TECHNICAL SERVICE BULLETIN
Distorted Or Muffled Sound Originating From The Instrument Panel Center Speaker

Model:	
Ford 2021-2026 Mustang Mach-E	Built on or before 20-Jan-2026

Figure 4

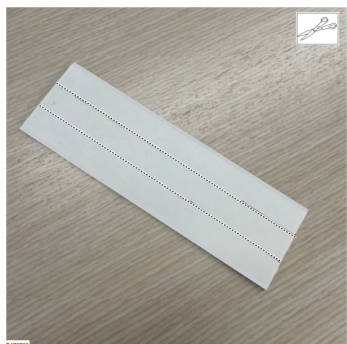
- (1). Divide the foam strip into three equal pieces as shown in Figure 4.
